NUMBER D2-14826

TITLE TECHNICAL FACILITY CRITERIA FOR THE MINUTEMAN LAUNCH FACILITIES - FRANCIS E. WARREN AFB, WYOMING (U)

The technical facility criteria document for the Minuteman Launch Facilities at Francis E. Warren AFB is issued as a supplement to the Wing III Launch Facility criteria presented in Boeing Document D2-13797. The complete Wing V Launch Facility criteria consists of the following:

CALC	R.L. ORNESS	5/30/3	REVISED	DATE	FWAFB LAUNCH FACILITY LAUNCHER SUPPORT BUILDING INTERFACE CABINET CONNECTION DIAGRAM	D2-14826
CHECK						FIG. 7-3
APR						PAGE
APR						24
					THE BOEING COMPANY

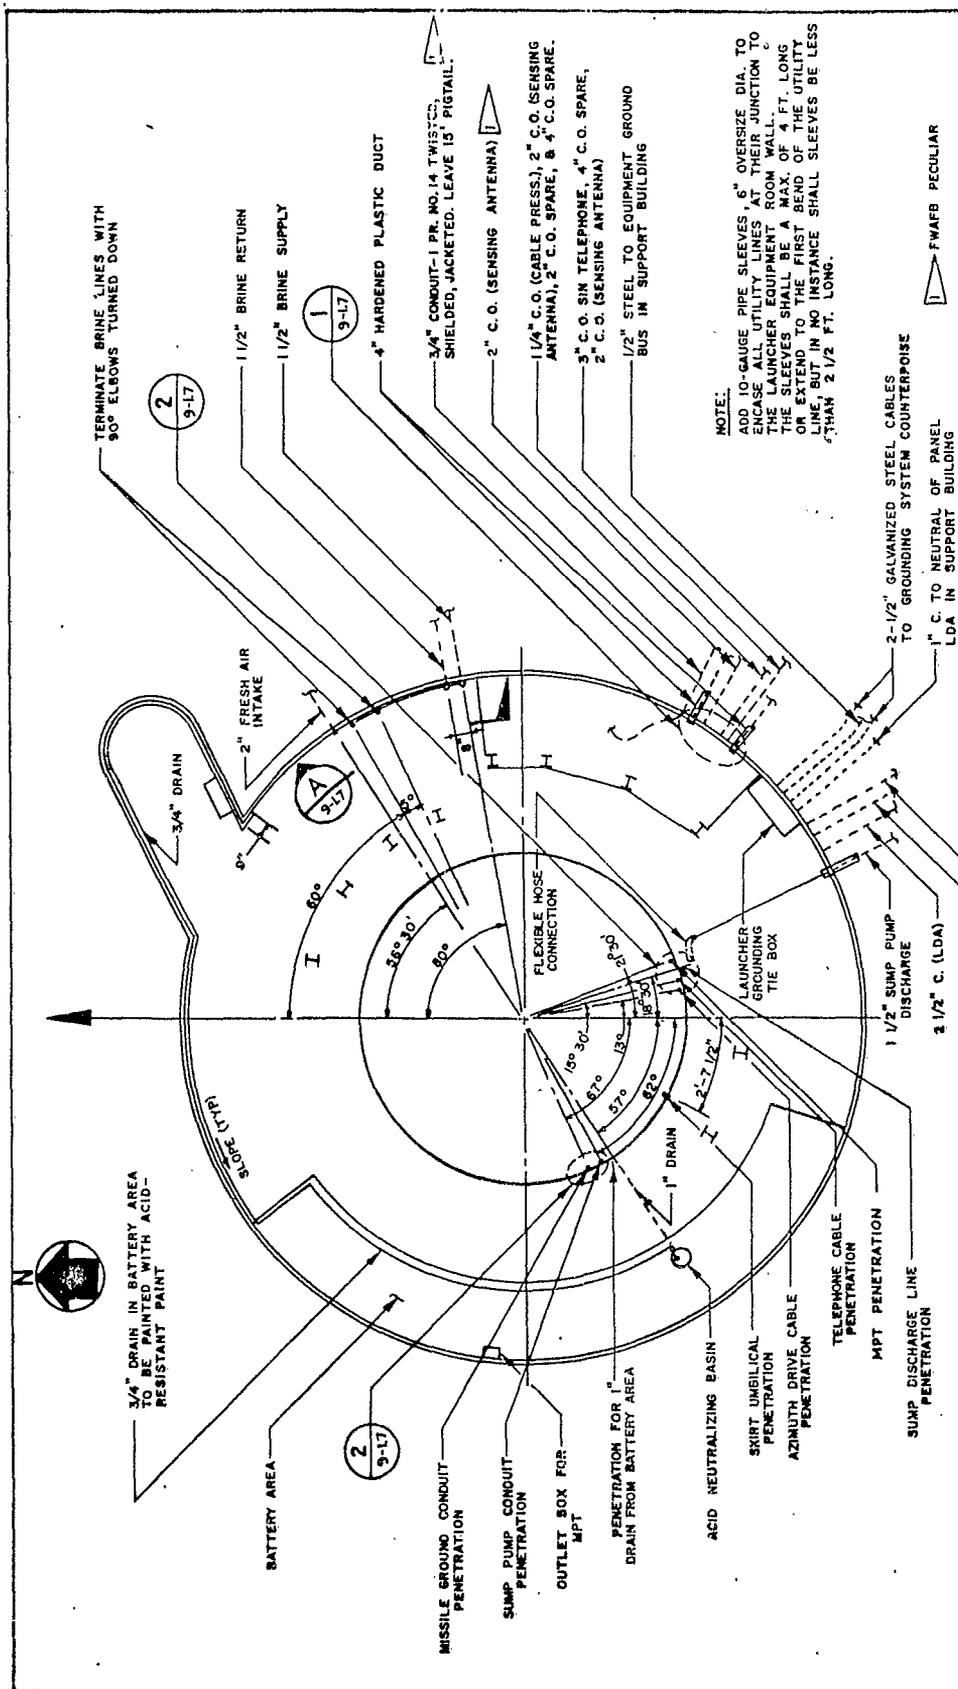
7.8.7 Figure 7-3 shows the wiring connection schematic for the Interface Cabinet. In lieu of a separate Security Terminal Cabinet as used in Wing III, the necessary security terminals shall be incorporated in the Interface Cabinet for Wing V.

02-14826
 FIG 9-1.6
 PAGE 27

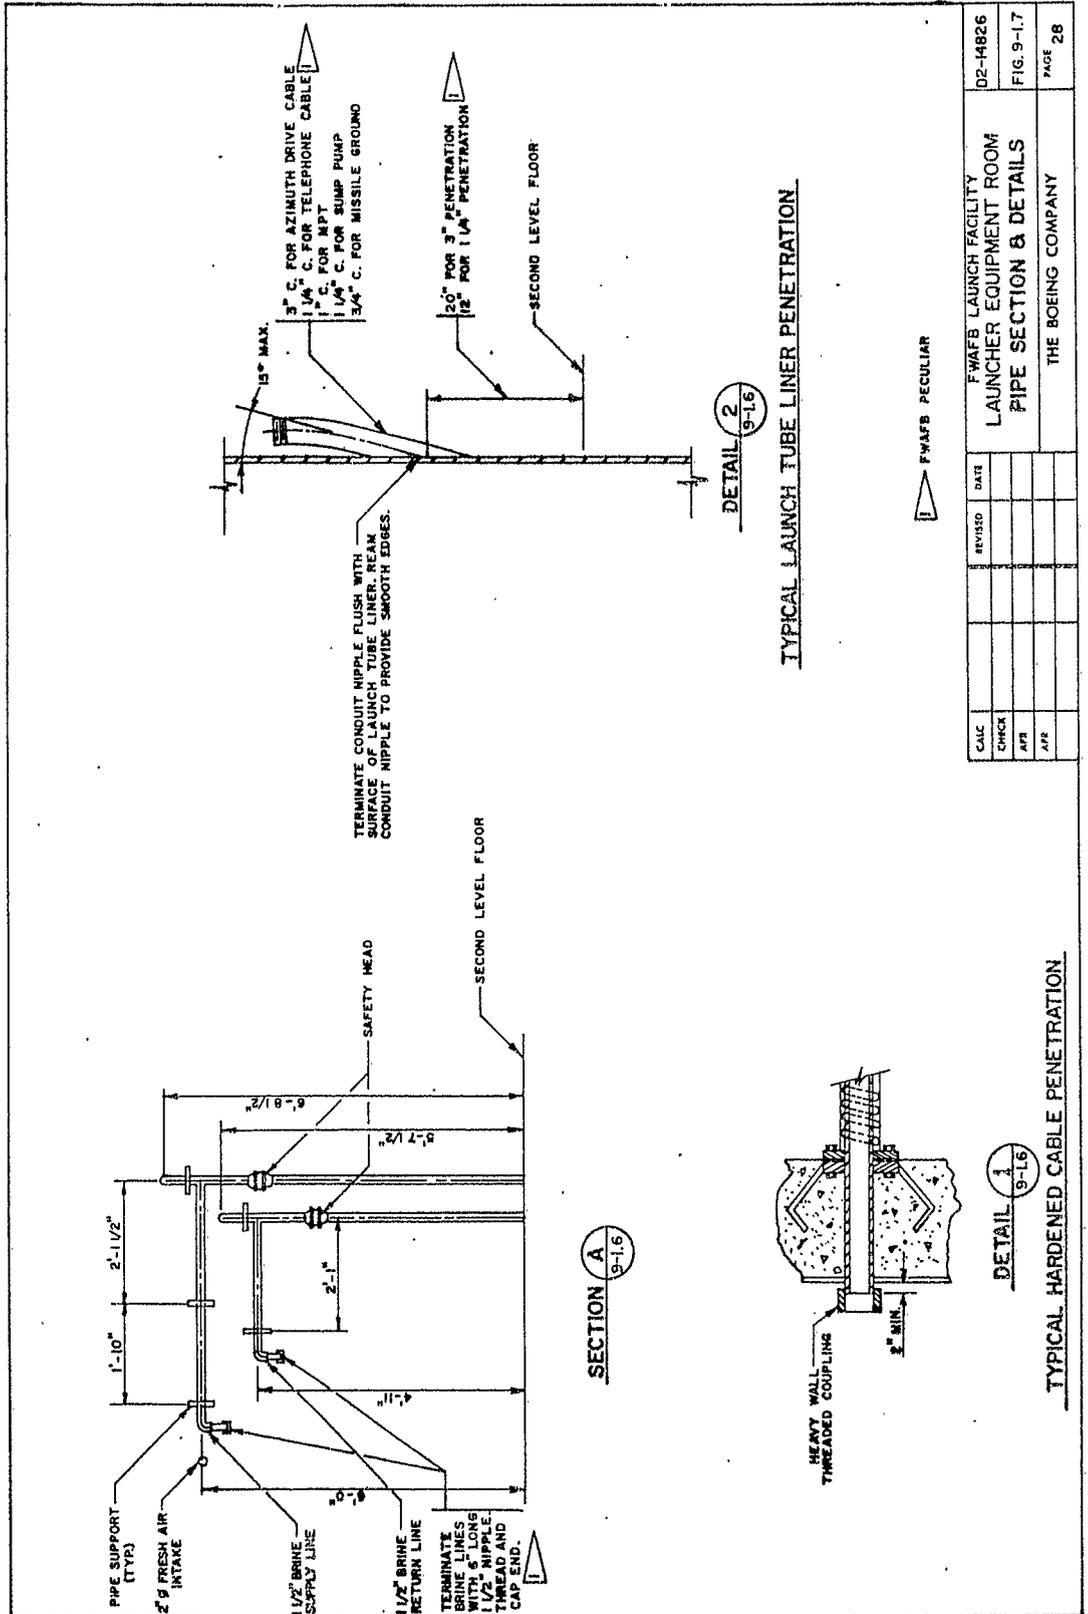
9.8.2 Figure 9-1.6 shows changes to electrical conduit arrangement and conduit sizes at MER wall penetration.

D2-14826
 FIG. 9-2
 PAGE 29

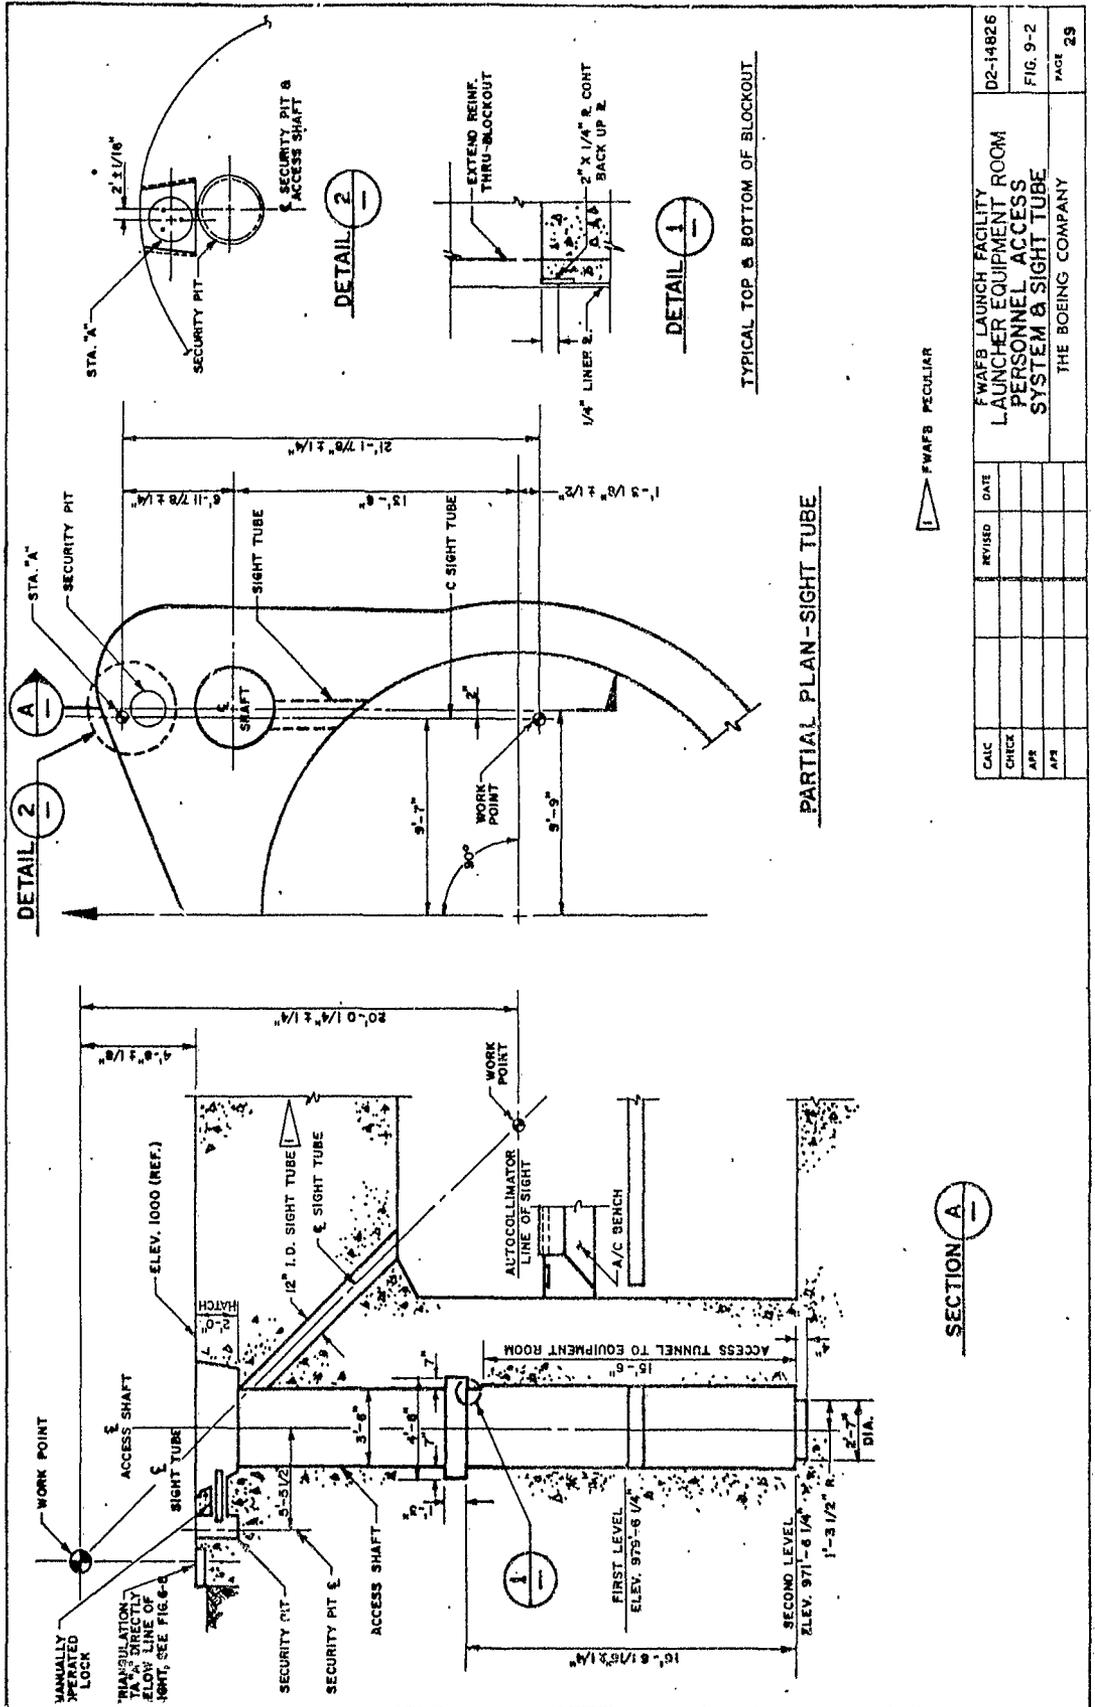
9.8.4 Figure 9-2 shows the Sight Tube inside diameter change from 24" to 12".

FWAFB LAUNCH FACILITY		02-14826	
LAUNCH TUBE		FIG. 10-1	
PLAN & SECTION		PAGE 33	
CAVC	REVISD	DATE	
CHECK			
JAF			
AVR			
THE BOEING COMPANY

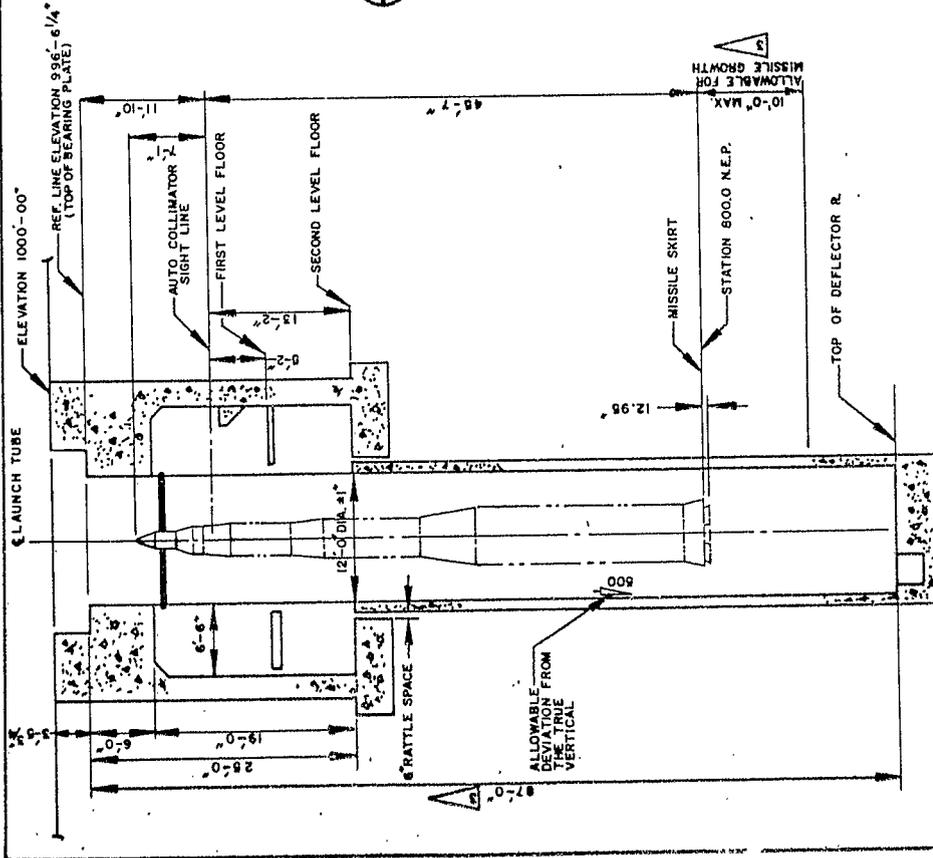
10.8.1 Figure 10-1 indicates the change in Launch Tube length measured from bottom of Closure to top of deflector plate from 77'-0" to 87'-0"; and adds the 10'-0" allowance for missile growth.

CALC		DATE	FWAFB LAUNCH FACILITY LAUNCH TUBE EQUIPMENT AND SERVICE LINES	02-14826
CHECK				FIG. 10-3
APP				PAGE
APR				34

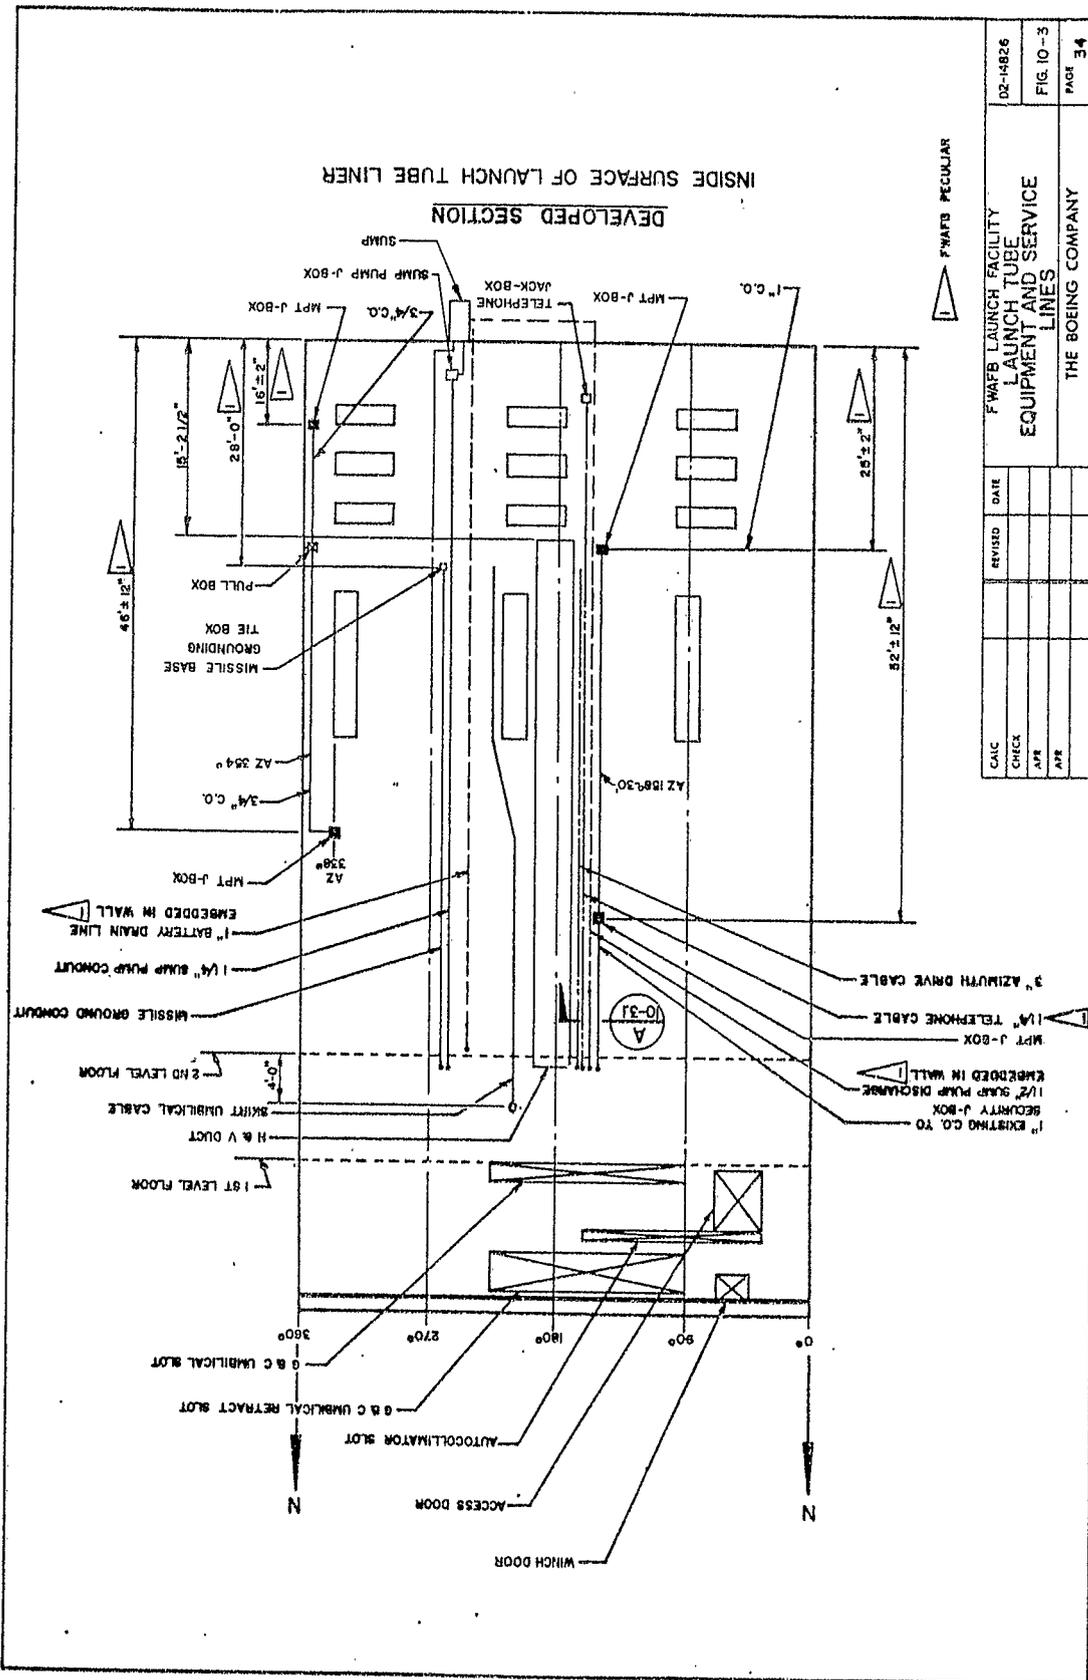
10.8.2 Figure 10-3 deletes the 14'-0" dimension from deflector plate to centerline of sump pump discharge line horizontal run; and indicates embedment and modification to layout of sump pump discharge line and battery drain line. Dimensional changes are shown from deflector plate to MPT J-Boxes.

D2-14826
 FIG 10-4
 PAGE 36

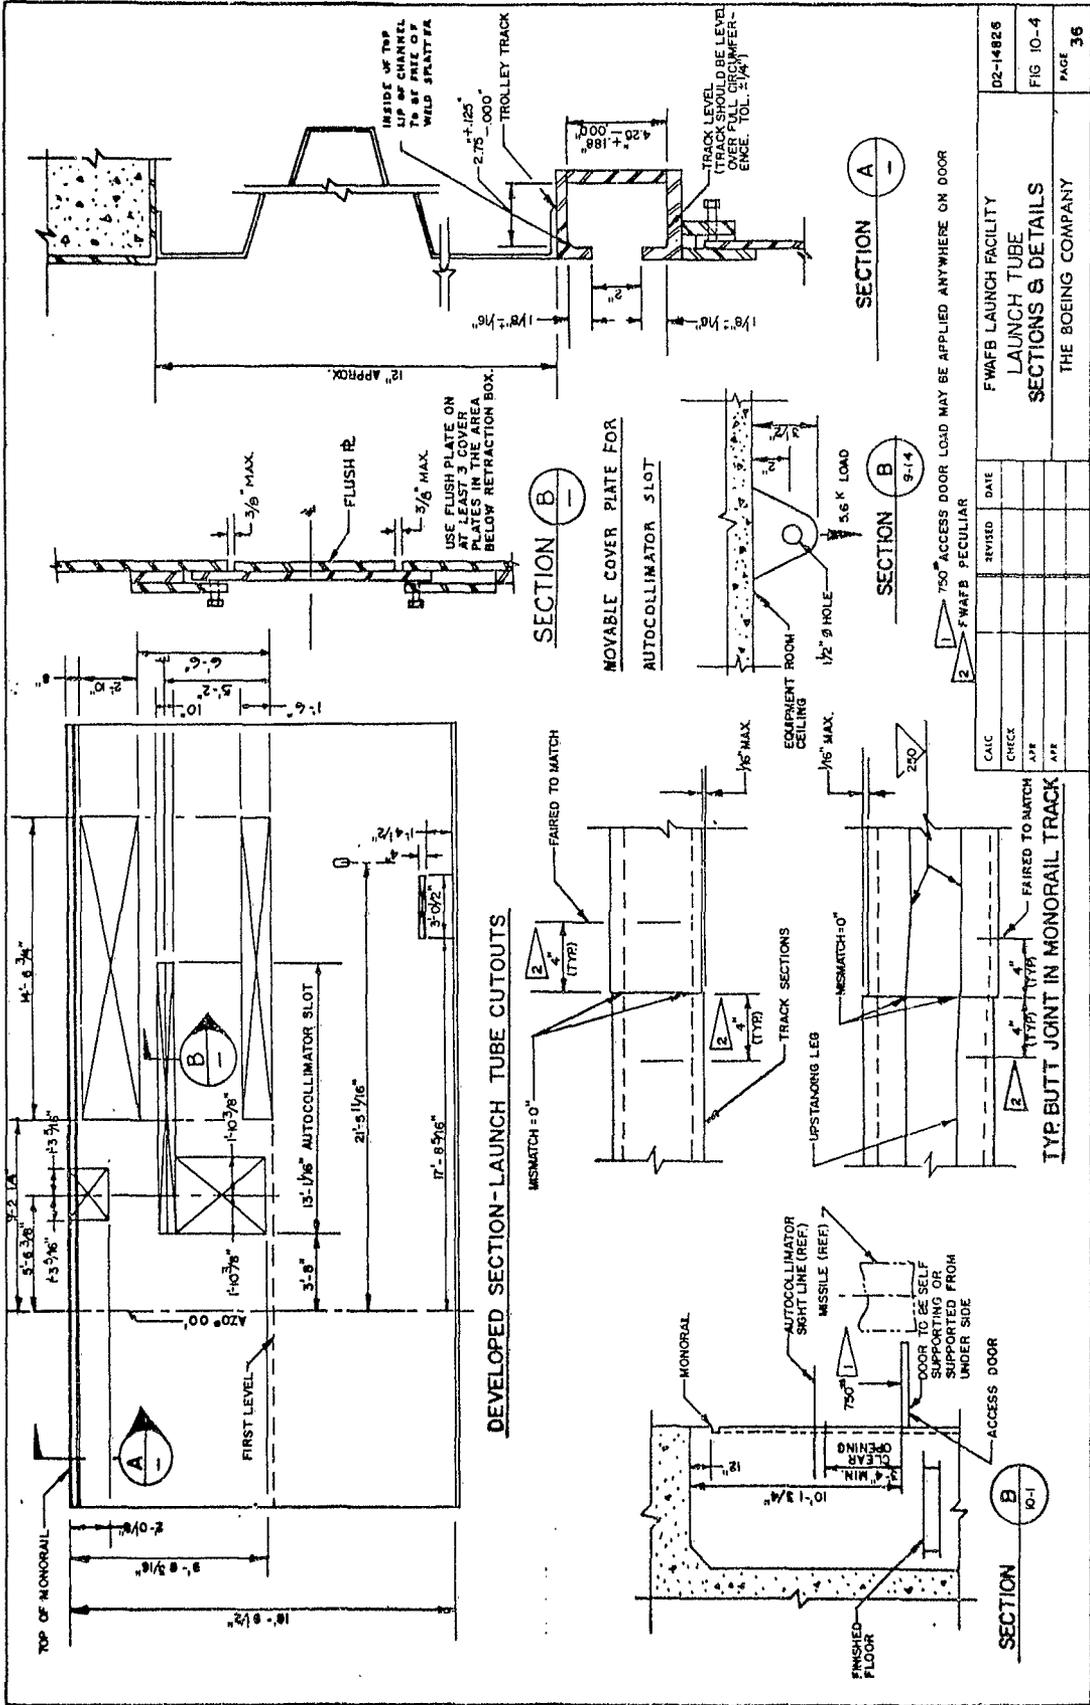
10.8.4 Figure 10-4. Details of typical butt joint in monorail track are changed to show increased "faired to match" requirement from 2 $\frac{1}{2}$ " to 4".

102-14826	REVISION	DATE	102-14826
FIG. 10-6	CALC		FWAFB LAUNCH FACILITY
PAGE 37	CHECK		LAUNCH TUBE
	APP		MISSILE SUPPORT LOADS
	APP		THE BOEING COMPANY

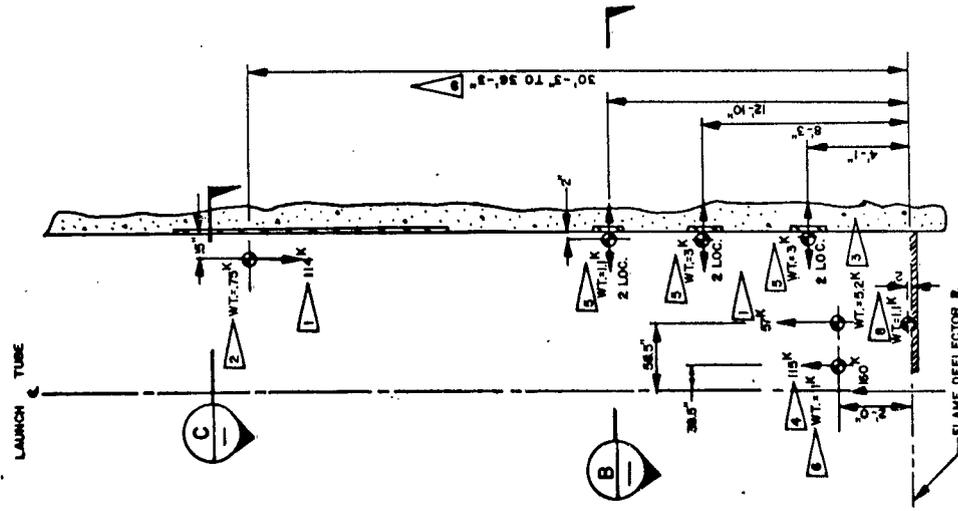
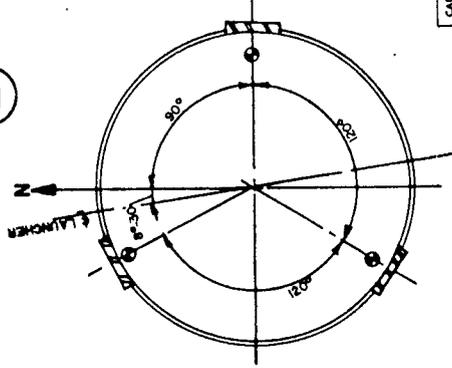
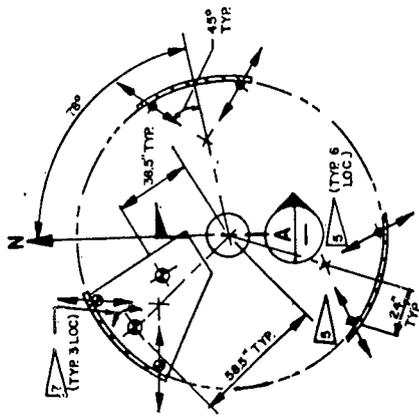
10.8.5 Figure 10-6 shows increased dimension range from deflector plate to load point at upper missile support plate from "20'-3" to 26'-3" to "30'-3" to 36'-3".
